From: Bruce Sounes [/O=STUDIO E/OU=FIRST ADMINISTRATIVE GROUP/CN=RECIPIENTS/CN=BRUCE]
Sent: 10/08/2012 10:51:08
To: Cate Cooney [Cate.Cooney@Exova.com]
CC: Paul Dunkerton [pdunkerton@kctmo.org.uk]; Grenfell [Grenfell@studioe.co.uk]; A.McQuatt@maxfordham.com; M.Smith@maxfordham.com
Subject: RE: Grenfell Tower
Attachments: IMG00011-20120306-1651.jpg; IMG00012-20120306-1651.jpg; IMG00048-20120411-1028.jpg; IMG00015-20120306-1654.jpg; IMG_6022.JPG; IMG_5870.JPG

Subject: Grenfell Tower

I tried to contact you earlier, but you were on site. I am working with Clare Barker on the existing fire strategy for Grenfell Tower and have a couple of questions I hope you can answer for me?

IMG00012 – Dry riser at residential floor level. Ground floor location as below.

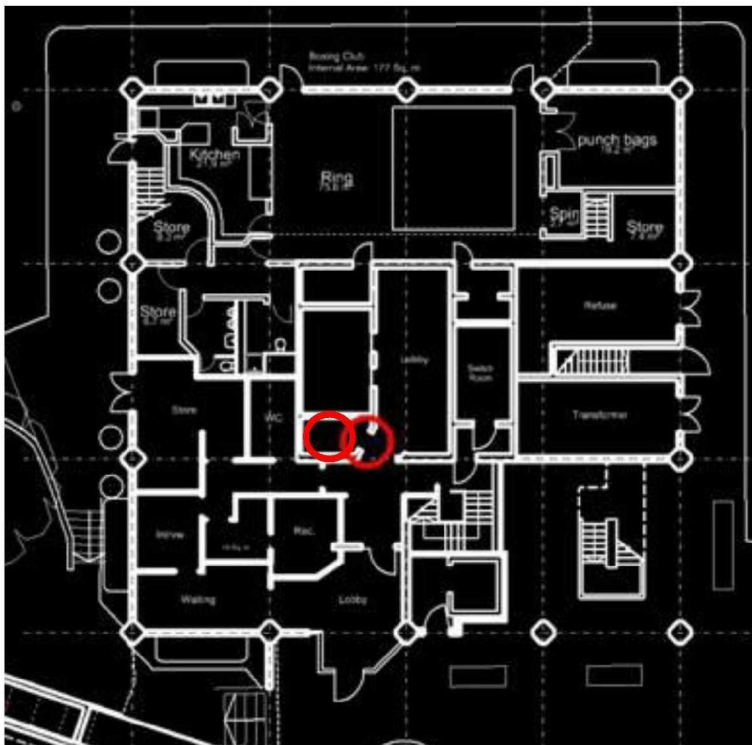
Is there a dry riser?

Dry riser - yes
